NOTICE OF A TYPE II DECISION ON A PROPOSAL IN YOUR NEIGHBORHOOD

CASE FILE NUMBER: LU 13-129202 AD

Proposal: In order to construct a new 3-car detached garage, the applicant is requesting an Adjustment to reduce the required 10 foot side and rear setback to allow the garage to be located within 5 feet of both the south (rear) and east (side) property lines. And, a 1-foot deep roof eave will extend within 4 feet of the south and east property lines, respectively. There will be no door and window openings on the south and east building walls.

SITE PLAN
SCALE 1" = 10'-0"
 OWNER: GINNY WHEELER
 2142 SW LAUREL
 PORTLAND OR 97225
 DATE: 3/19/13

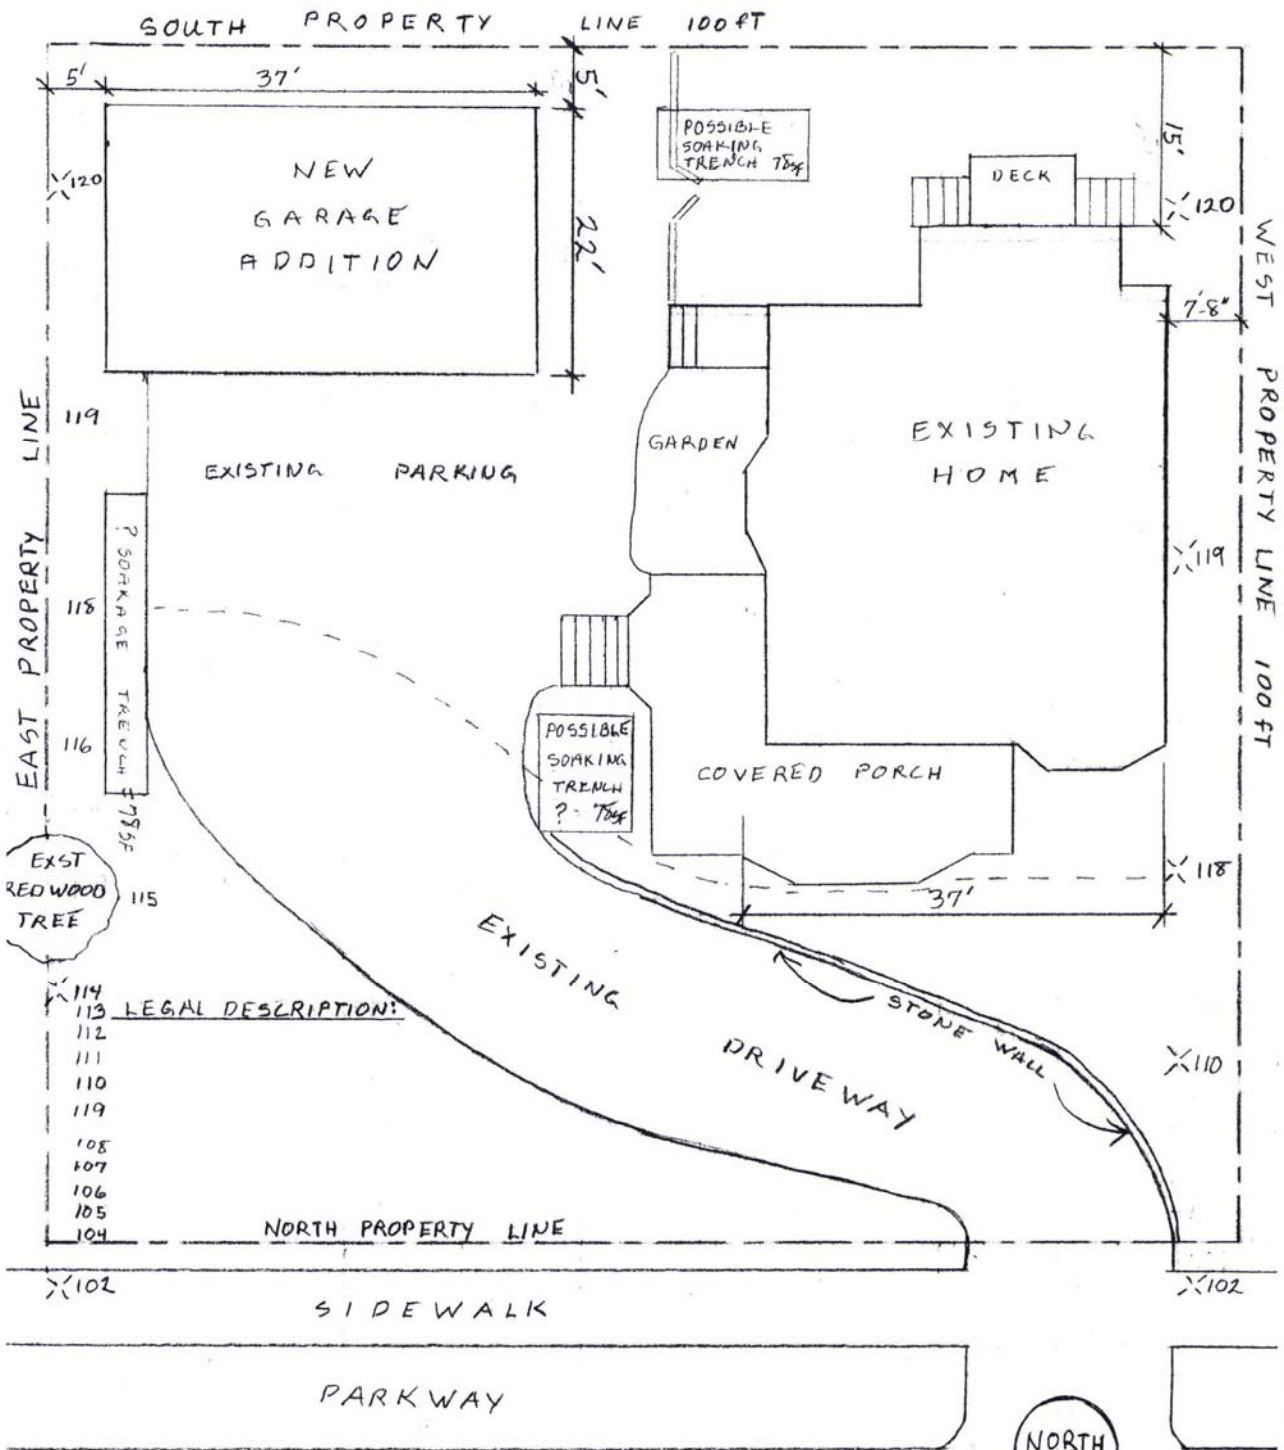
- b. The provided site plan indicates 3 potential areas for a storm disposal soakage trench. The provided locations appear to have conflicts draining toward the house, within setbacks to the subject and neighboring houses (10 feet to foundations), and / or conflicts with tree roots.

- d. BES requires at minimum, that the applicant submit a completed Simplified Approach Form (Form 1 from [Appendix D.3](#) of the SWMM) and preliminary utility plan showing adequately sized stormwater management facilities and setbacks that meet SWMM requirements (SWMM exhibit 2-1) at time of building permit. In order to verify whether on-site infiltration is feasible, the results of Simplified Approach infiltration test(s) on the subject site per [Appendix F.2](#) must be included. Infiltration test pits must be as close as possible to proposed infiltration facilities, and tests must be performed at the depth of the proposed facilities. Indicate on a submitted plan the approximate location of the test pit(s).

- e. **Since soils in southwest Portland typically do not infiltrate well, BES strongly urges the applicant to provide a Presumptive Approach Stormwater Report that includes Presumptive Approach infiltration testing and stormwater facility calculations.** Presumptive testing and calculations would need to be provided by a professional engineer (PE), certified engineering geologist (CEG), or registered geologist (RG) in accordance with [Appendix F.2](#). BES may require a Presumptive Approach test and report at time of building permit.

LN 13-129202 AD *Exhibit C.2*

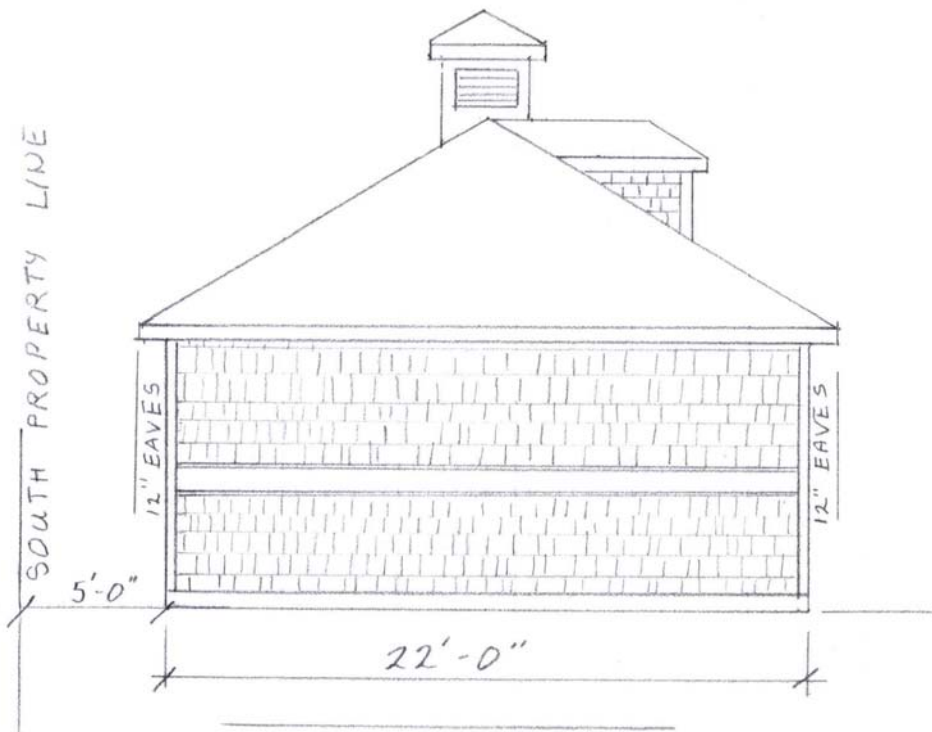
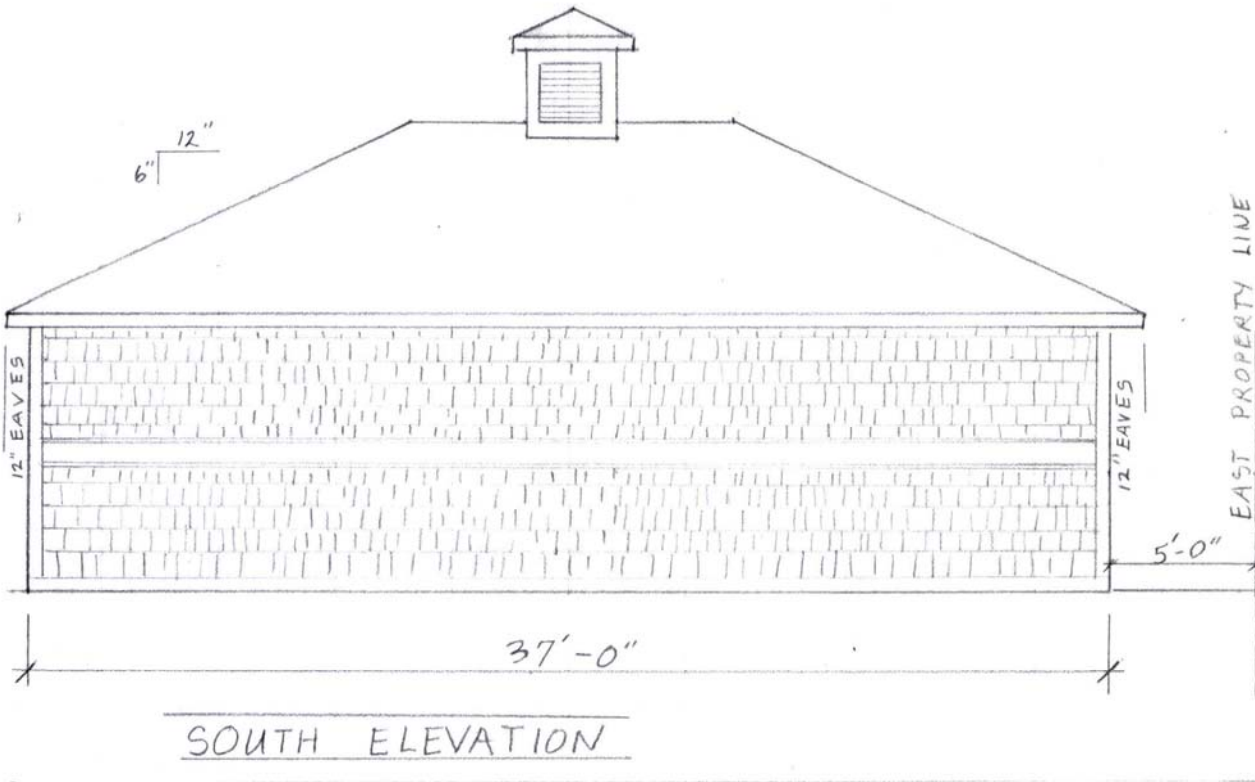
The proposed 814 square foot, 3-bay garage is 37 feet wide. The proposed structure is wider than the home (excluding the covered porch area). The south wall of the garage will present to the abutting properties a 333 square foot continuous blank (solid) wall and a relatively large roof line. The roof line will provide for a deep lofted ceiling area and or future upper level storage or useable space. The two small north facing dormers

Findings: All three letters received from neighbors raised concerns about the scale of the garage. One of the neighbors considers the proposal an “esthetic eyesore”. The submitted exterior elevations illustrate elements of a quality design-- deep eaves, wide trim, shingle siding and ornate carriage-style garage doors are shown. The proposed garage evokes thoughts of a Colonial or Country-style carriage building with carriage-like doors, a cupola and weathervane. The design does not conflict with the grand 1906 home with wrap-around porch. However, even with such a quality design, staff agrees with the neighbors that a 333 foot south-facing blank wall detracts from the appearance of a residential area. The structure will detract from the livability of the neighbors to the south. Further, because the home on the eastern abutting lot is relatively close to the common property line, the 13 foot tall (measured to the mid-point of the primary roof) structure with approximate 200 square foot solid blank wall will create livability impacts to neighbors at 2124 SW Laurel, as well.

A setback reduction from 10 to 5 feet could be found to meet this approval criterion—consistent with the development character if the garage is reduced in size and scale. A smaller 22’ by 24’ garage with a roof pitch of 5/12 or lower could be found to be consistent in scale and character with the surrounding development. Staff explained this to the applicant and suggested the applicant revise the proposal. Because the proposal was not revised, BDS finds this criterion is not met and therefore, the request must be denied.
